**Department of Transportation**  
**Rapid City Region Office**  
2300 Eglin Street  
P.O. Box 1970  
Rapid City, SD 57709-1970  
Phone: (605) 394-2244  
FAX: (605) 394-1904

Re: Southeast Connector signing changes.

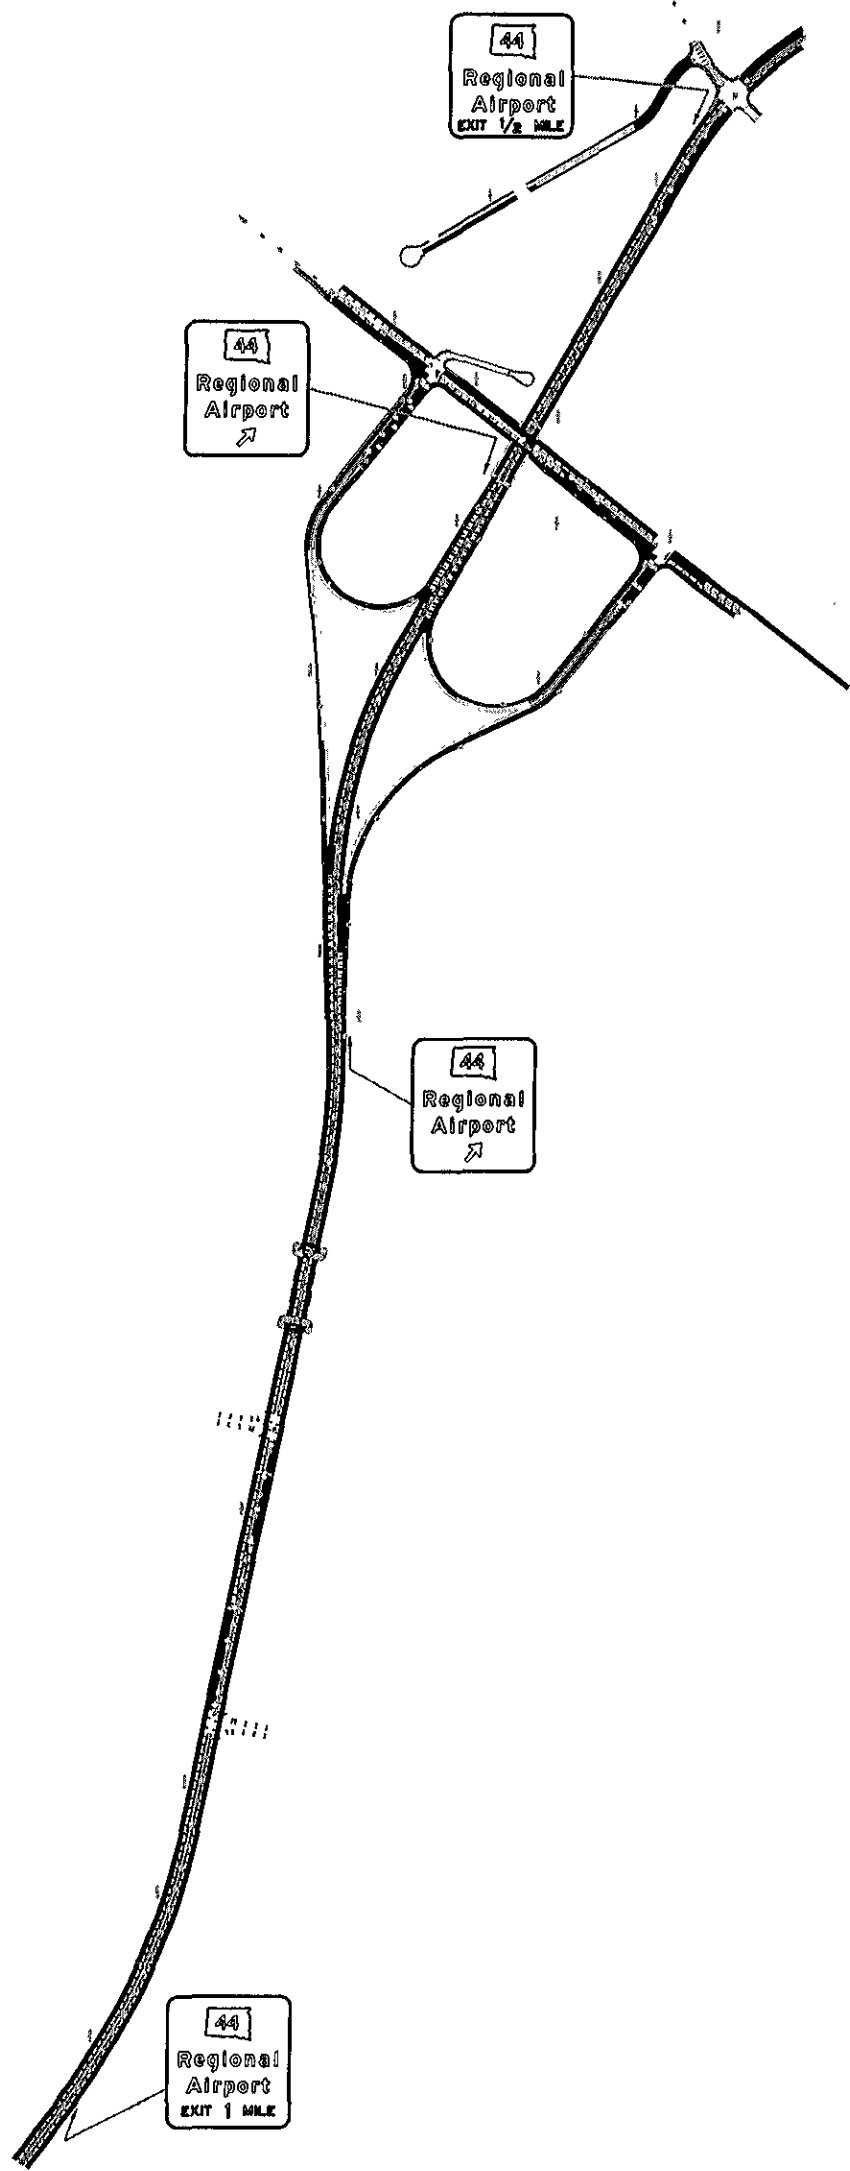
We were asked by City Councilman Sam Kooiker to consider changes to our signing along US16B/SD79, Southeast Connector, to allow for display of destination **Rapid City**. Councilman Kooiker offered that there may be Interstate travelers who exit I-90 at Exit 61 and completely miss the opportunity to access our city at the SD44 interchange.

As we consider options open to us, we much prefer to select one that does not obligate us to completely replace existing sign post and footing assemblies. We have to maintain adequate legend size and the existing sign posts and footings are not suitable for much increase in overall sign panel size.

The attached layout details our preferred signing changes. Please note the legend for Regional Airport has been replaced with the well recognized Airport symbol sign. This allows sufficient space to display legend **Rapid City**.
